TO: Brynhildr Halsten, Galloway & Company
FROM: Ashley Chasez, Planner I
DATE: October 25, 2023
SUBJECT: Douglas 234 F6 AMD 1 L4 - Dunkin Donuts
Review Comments 02

Staff Comments 02
SP22-041
Douglas 234 F6 AMD 1 L4 - Dunkin Donuts
10/25/2023

EXISTING CONDITIONS & DEMOLITION PLAN

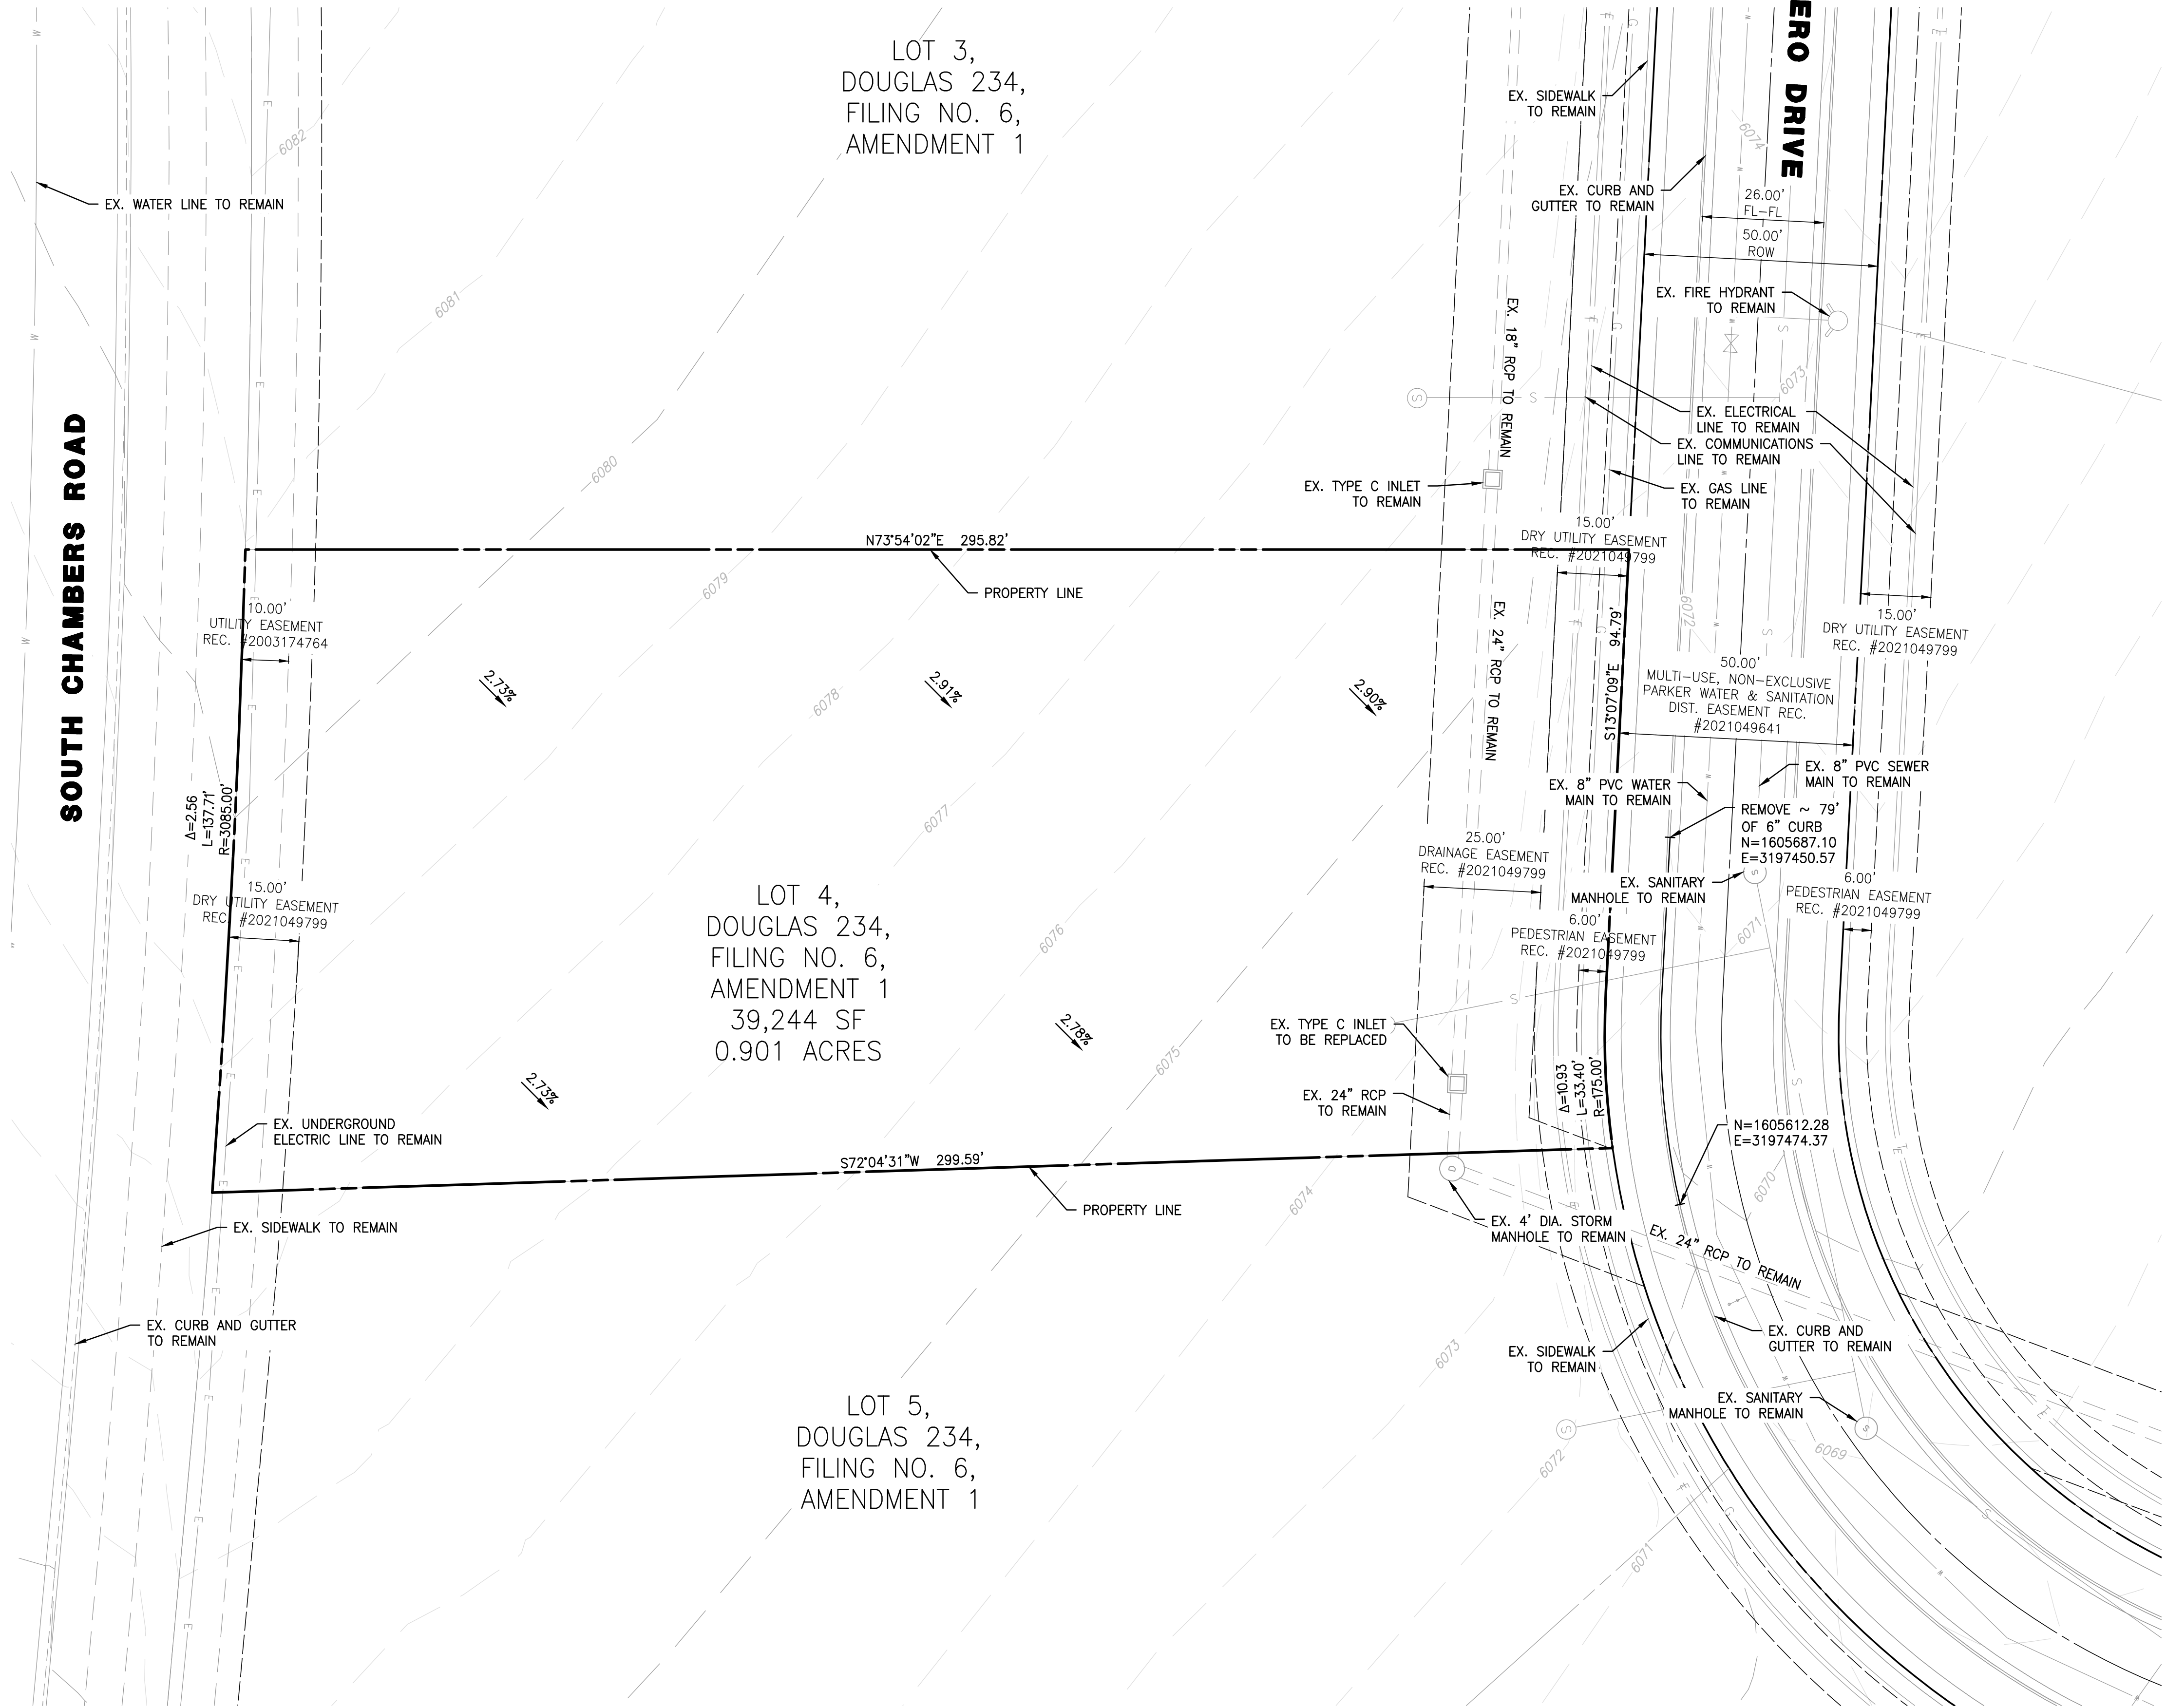
Add crosswalk stripes

Correct the legend to — match what is shown on the plan

2 EXTERIOR ELEVATION - FRONT
SCALE: 1/4" = 1'-0"

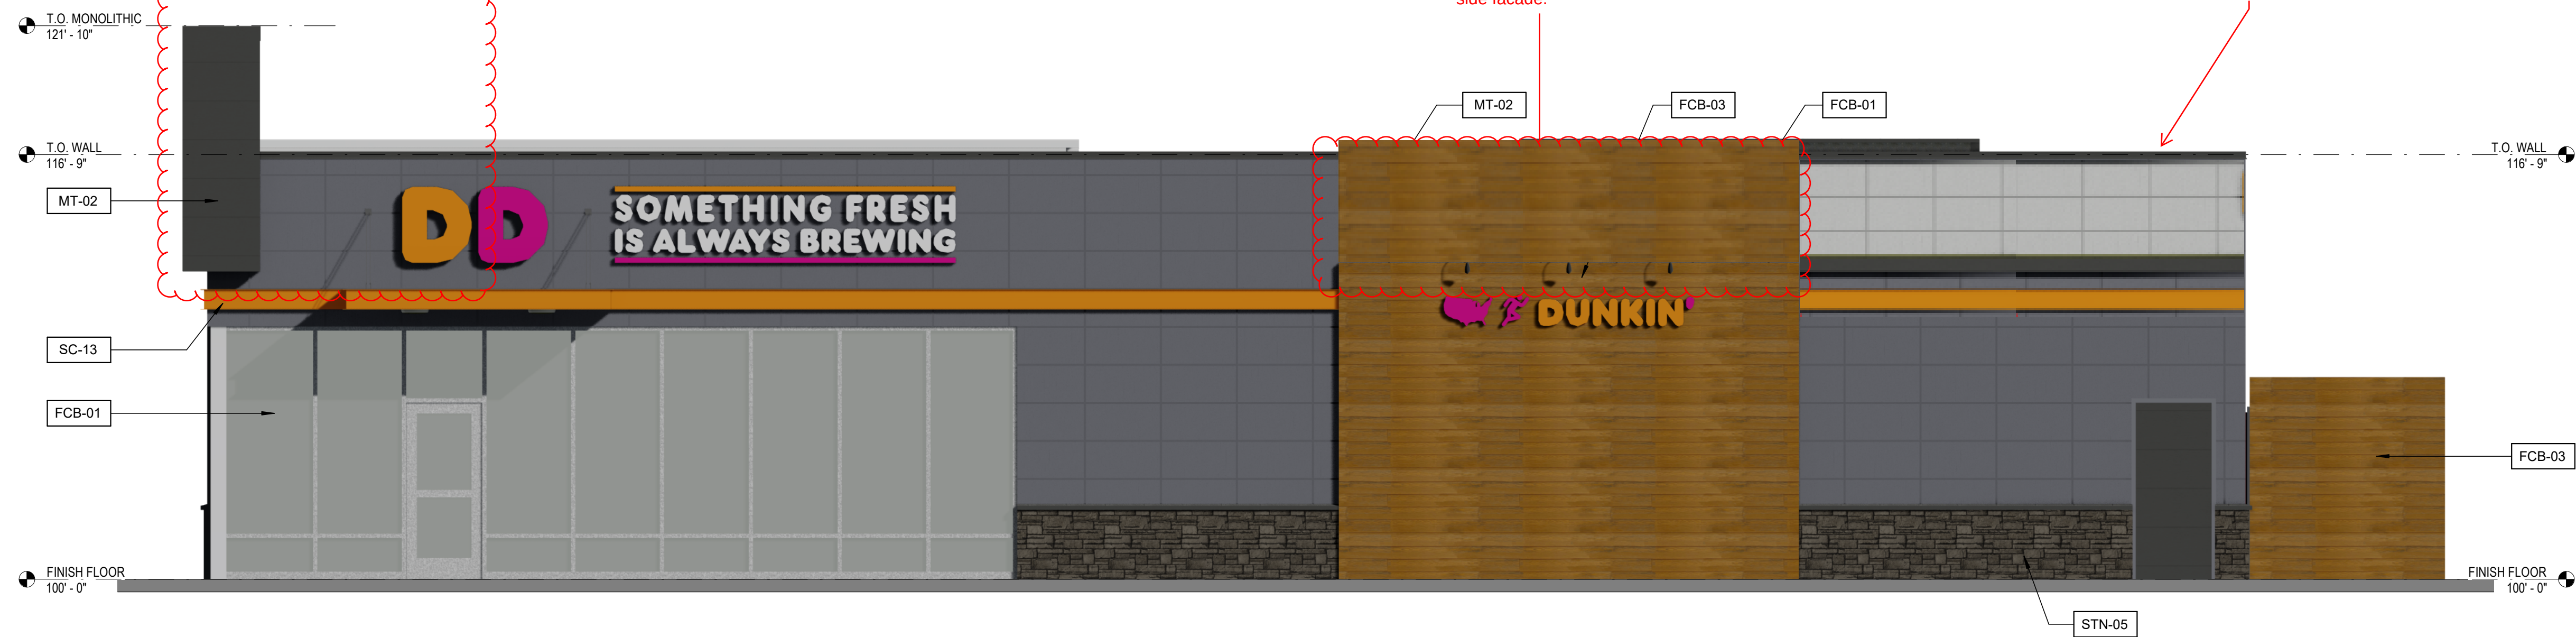
- Include cardinal directions

Wrap this element around the corner to create a true corner tower feature.
